## Refuge Media Group (RMG)

### Exhibit 1 Expedited Processing Requested

### Map Showing Change in Service Area

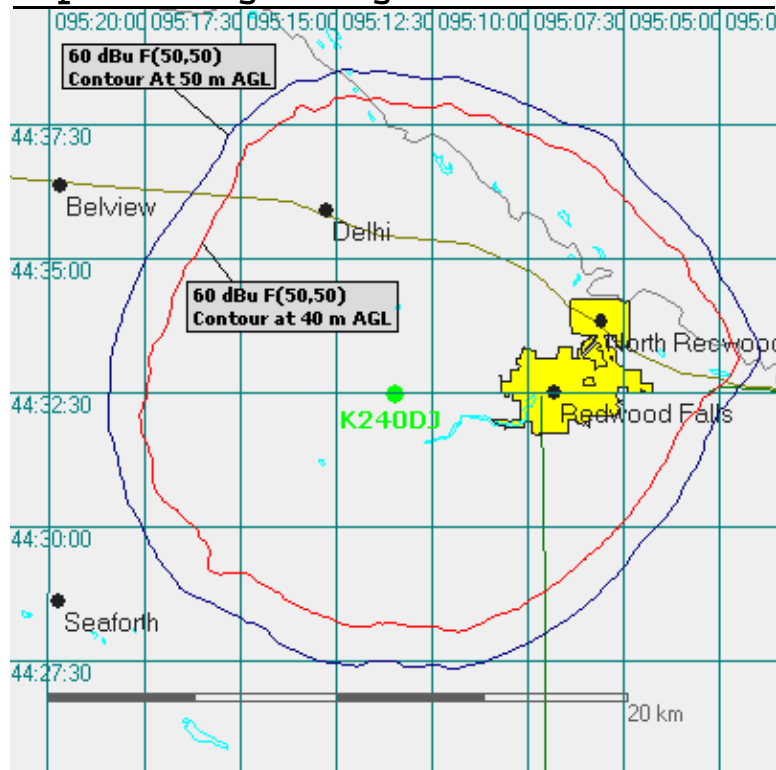
The specified height above ground level of 50 meters was originally available, but, due to circumstances beyond our control, the tower owner had to lower our height as we were signing the final agreement. The COR was lowered by 10 meters to 40 meters above ground level. This reduces the maximum distance (of the 12 evenly spaced radials) to our coverage areas and interference contours as follows:

Original distances to contours at 50 meters AGL (83.2 meters max of 12 radials:-)

60 dBu F(50,50): 11.7 km ; 40 dBu F(50,10): 40.2 km; 54 dBu F(50,10) 17.1 km; 100 dBu F(50,10) 1.1 km

New distances to contours at 40 meters AGL (73.2 meters max of 12 radials:-)

60 dBu F(50,50): 11.1 km ; 40 dBu F(50,10): 37.6 km; 54 dBu F(50,10) 15.8 km; 100 dBu F(50,10) 1.1 km
